STATE OF WASHINGTON
DEPARTMENT OF ECOLOGY

M E M O R A N D U M

To: Myron Saikewicz and Harold Porath
From: Marc Heffner *MCH*
Subject: Leavenworth Sewage Treatment Plant Class II Inspection,
June 12-13, 1984

Figure 4. Flow and MLSS concentrations allowing clarifier solids loading to remain under 25 lbs/ft²/D
 - Leavenworth, June 1984.

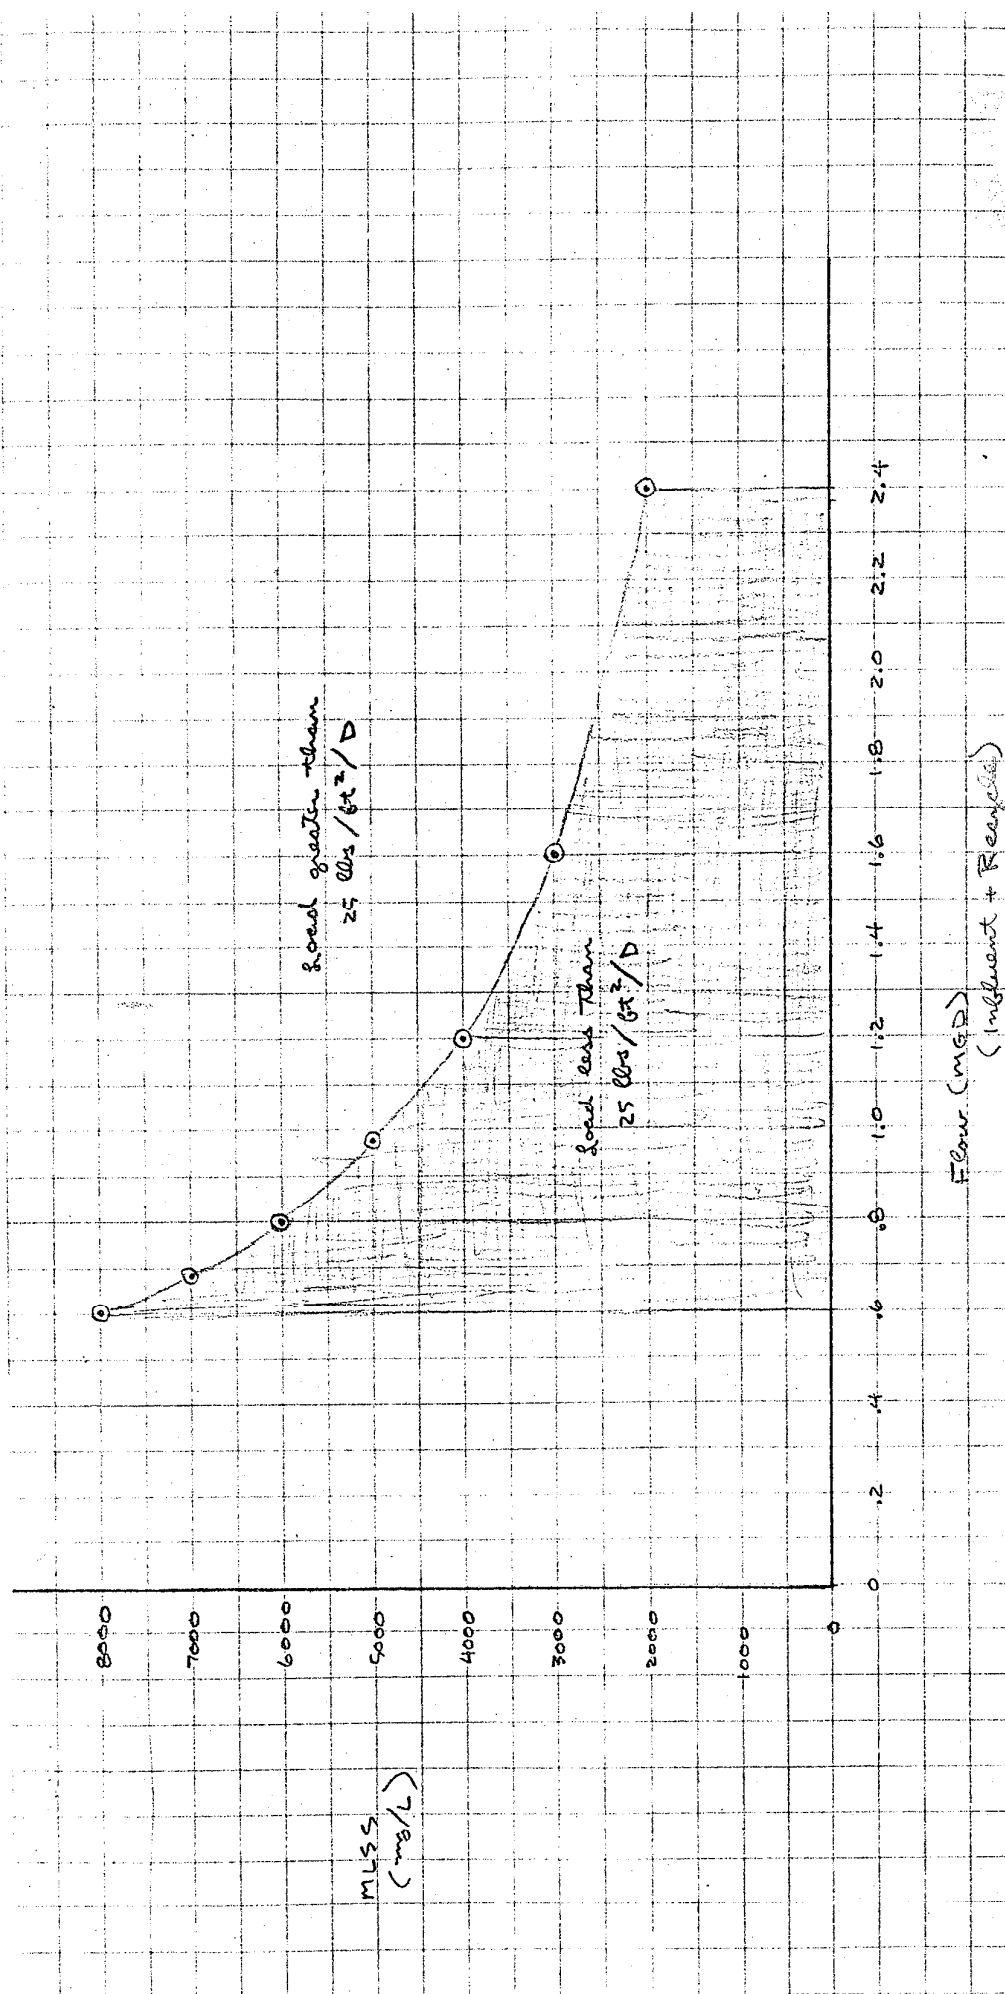
Figure 4 illustrates the relationship between the MLSS concentration and the flow the clarifiers could handle staying within the WDOE criteria. Judging from both the loading and operator's concerns about clarifier solids loss, any increases in MLSS concentration without corresponding decreases in total flow to the clarifiers should be avoided. A reduction in the MLSS concentration may decrease the probability of higher flows causing solids loss from the clarifier.
